Technical Service Bulletin

60 Water entry into cabin from the sunroof area

60 20 45 2056944/5 November 3, 2020. Supersedes Technical Service Bulletin Group 60 number 20-44 dated October 7, 2020 for reasons listed below.

Model(s)	Year	VIN Range	Vehicle-Specific Equipment
Audi e-tron Sportback	2020 - 2021	All	Not Applicable
Q3, Q8, and Audi e-tron quattro	2019 - 2021	All	Not Applicable

Figure 4. Front and rear glass panel adjustment.

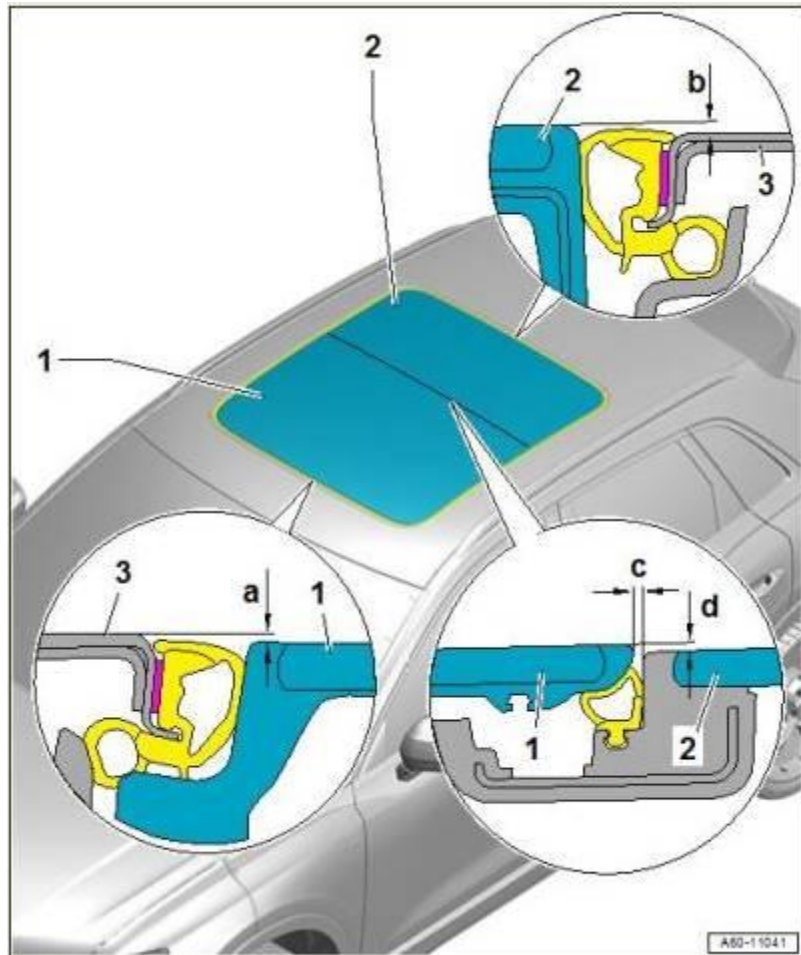
Check all adjustment axes of the sunroof glass panels for poor adjustment (Figure 4).

If after all dimensional measurements are made on the sunroof glass panels a problem is found make the necessary adjustments to the sunroof glass panels.

Figure 8. Locating points for the sunroof wind deflector.

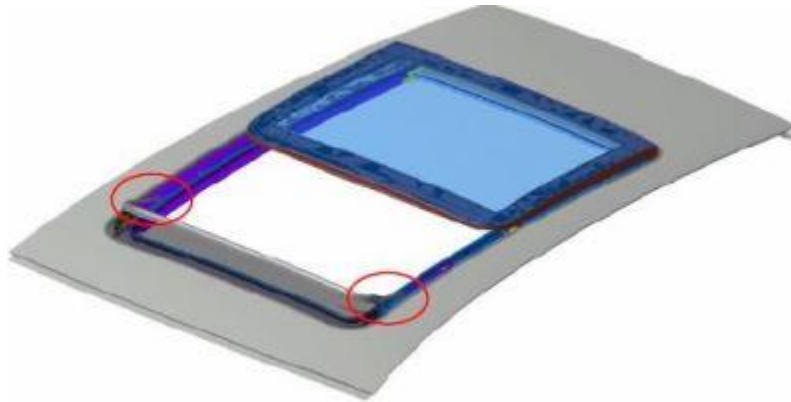
5. Open the front sunroof panel completely and locate the mounting points for the sunroof wind deflector (Figure 8).

Figure 10. Area of sunroof frame to be cleaned.

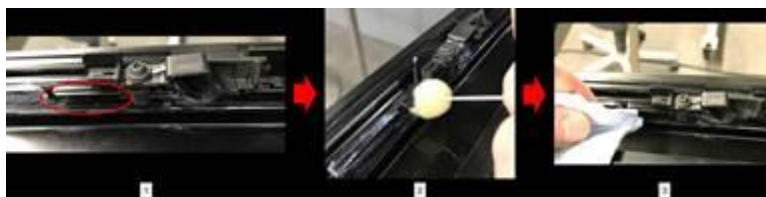
7. Using a primer applicator D 009 500 25 (or equivalent) and D 009 401 04 all purpose cleaner (or equivalent) thoroughly clean the area shown (Figure 10). It should be free of any lubricant or contaminants and completely dry.

Figure 12. Area of sunroof glass panel to be modified.

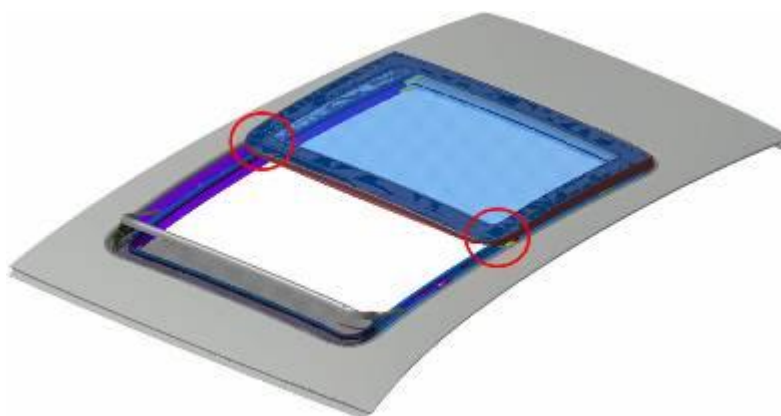
9. Next, a modification will be made to the sunroof glass panel (Figure 12) by bonding two small pads to the front corners just inside the rubber 'skirt'. The purpose of this modification is to create a gap between the 'skirt' and the sunroof mechanism beside it, and as a result, prevent water from making contact with the sunroof mechanism and possibly breaching the water channels.

Figure 16. Positioning and application of the 10mm x 10mm pads.

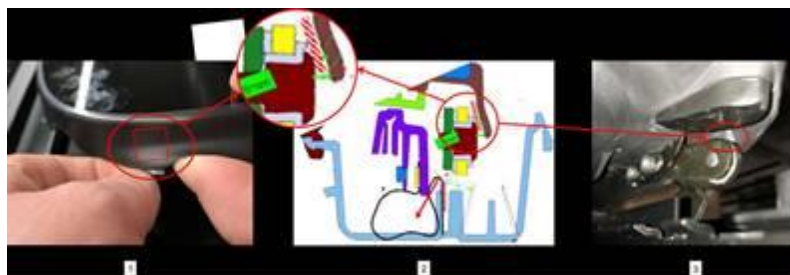
13. Bond each pad to the front areas of the sunroof glass panel 'skirt' as shown in figure 15. A cut away drawing is included to illustrate the precise positioning of each pad from the inside (Figure 16).
